EXHIBIT A: PROPOSED CODE CHANGES

12-16-2015

ATTACHMENT B: LEGISLATIVE LANGUAGE

Lede

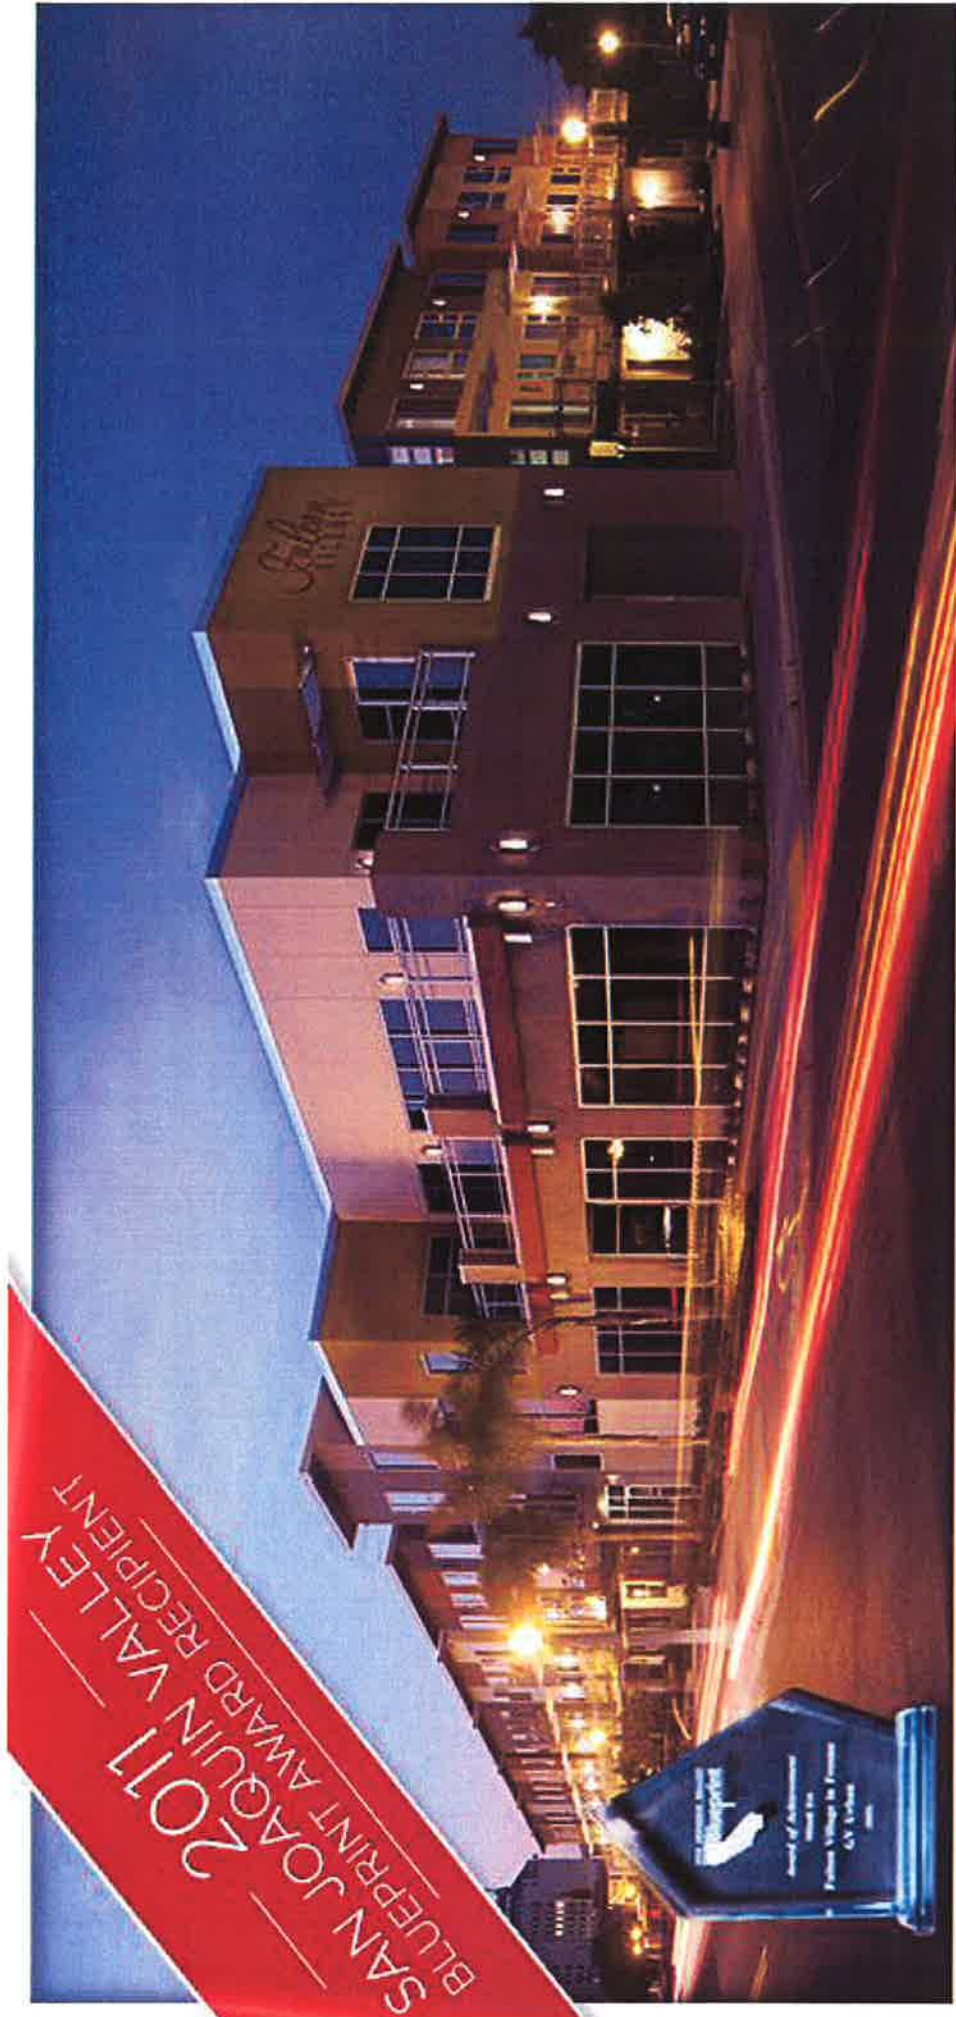
Doesn't meet the requirements:

- Window Vertical Proportions: It doesn't have 50% of the windows taller than wide, and
- Window Depth: It doesn't have trim, per requirements, all around the window, and is not recessed.
